SLIM CHICKENS SITE PLAN

TOWN OF PARKER PLAN REVIEW

SITE PLAN
SLIM CHICKENS
COVER SHEET
SVC OF S. PARKER ROAD AND E. PINE LANE, PARKER, CO 80134

EES
 ENTITLEMENT AND ENGINEERING SOLUTIONS, INC.
 501 S. Cherry St. Suite 300
 Denver, CO 80246
 303-572-7997 www.ees.us.com

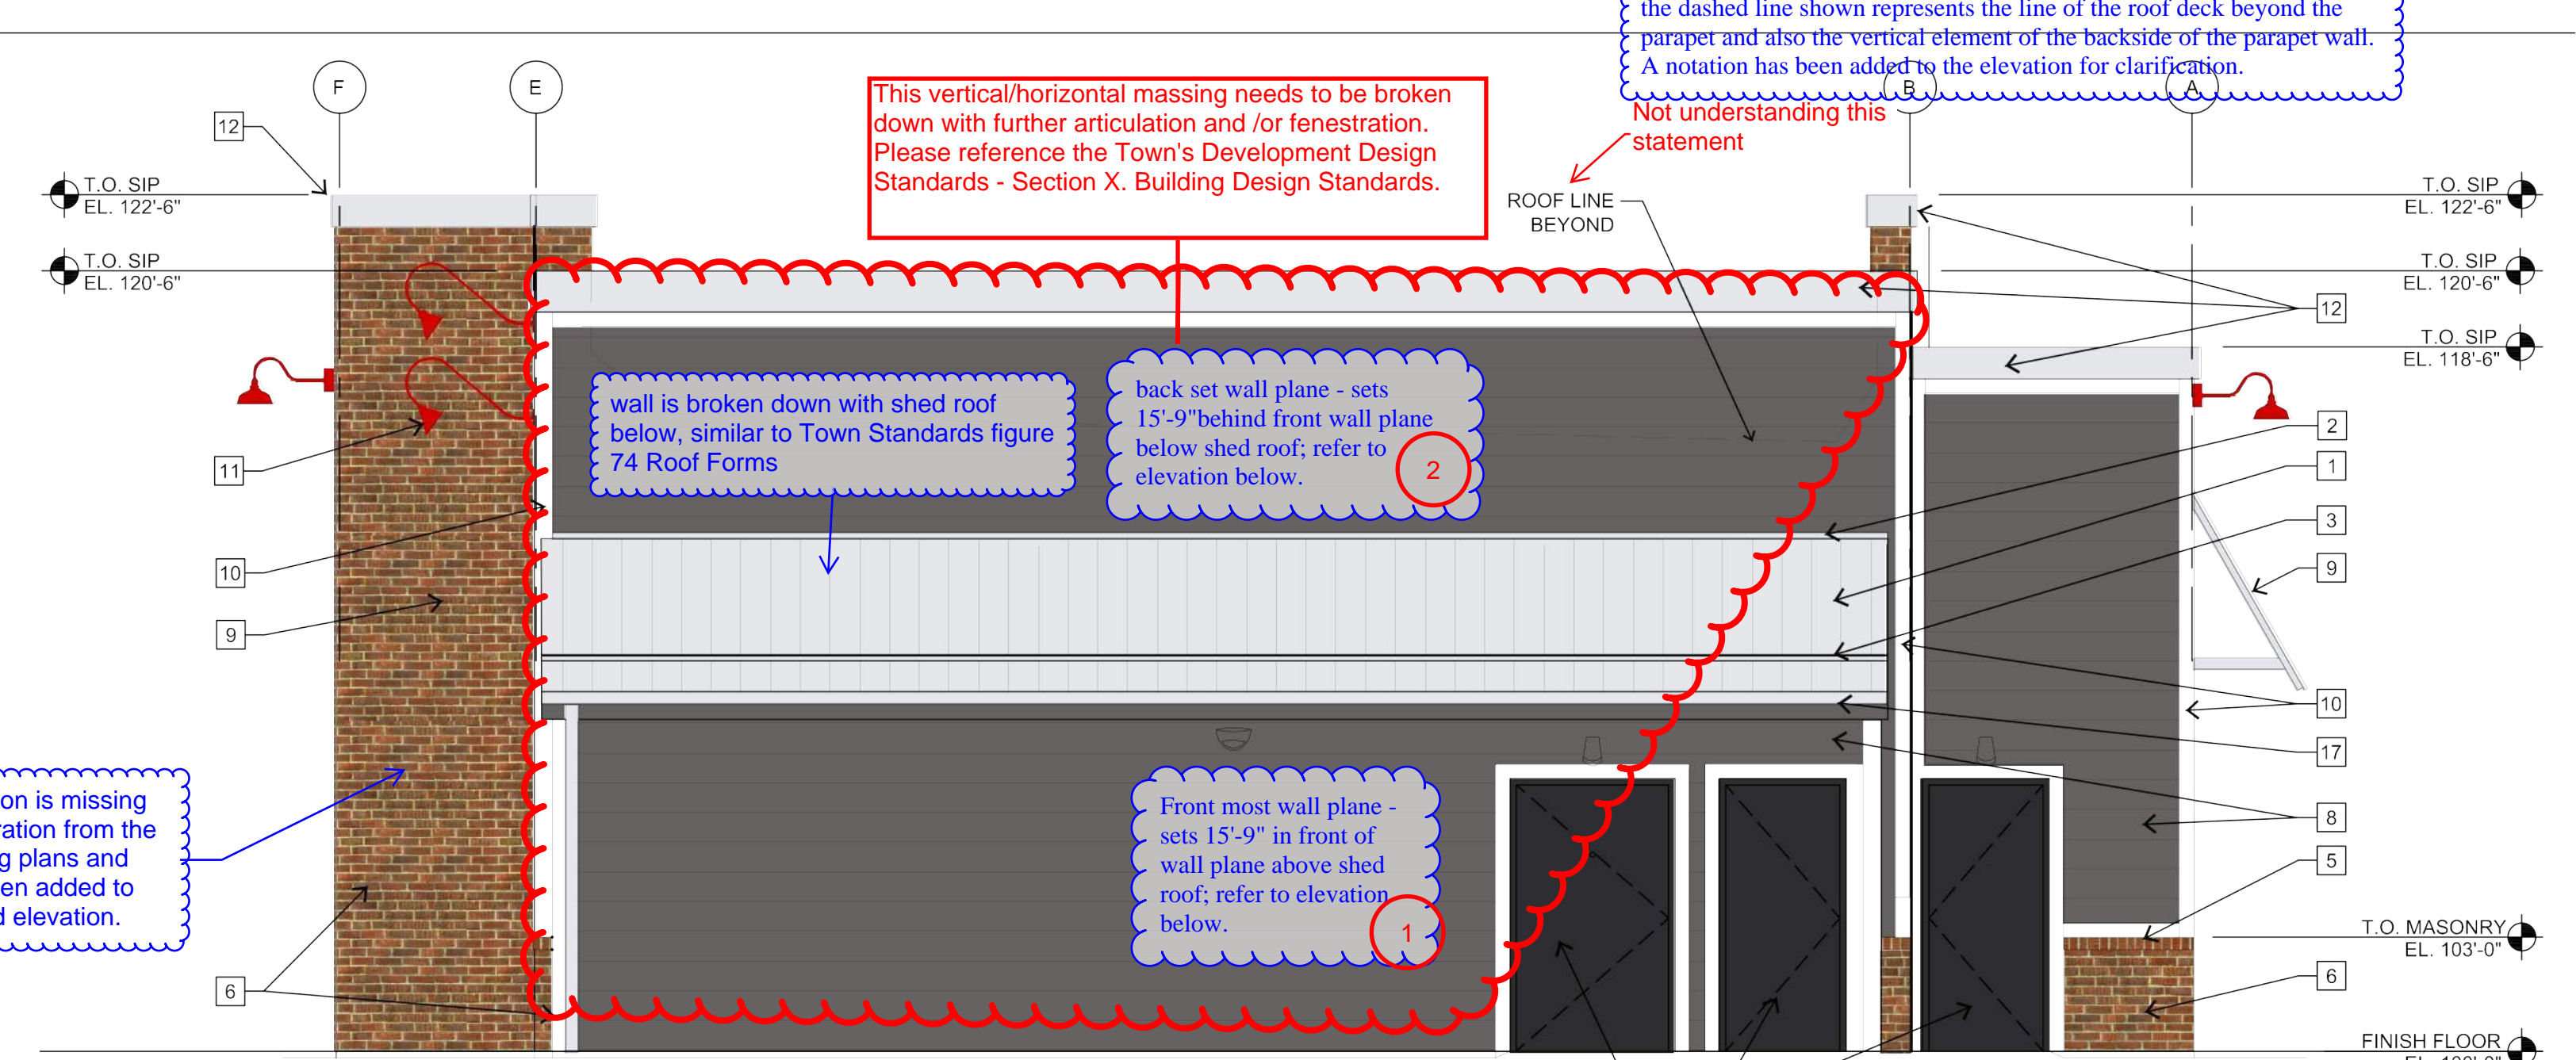
Large blank area. Please add additional articulation and/or fenestration for architectural interest - especially since this is on a highly visible roadway.
 The elevation has been revised. Additional material has been added to top of wall to decrease the area of lap siding. IREA panel size more accurately shown reducing amount of visible lap siding.

Should lights be offset to side since they'll be shining down on awning?

Identify signage dimensions

The elevation has been revised. Additional material has been added to top of wall to decrease the amount of lap siding. "Future" Signage/Graphics on the wall will create additional interest for the wall elevation. The kitchen is beyond this wall which means no fenestration per Town Standards as spandrel glass and fake windows are not permitted for fenestration.

Town of Parker Standards Note removed from sheet.

Note updated to require Town Approval if changed prior to construction.
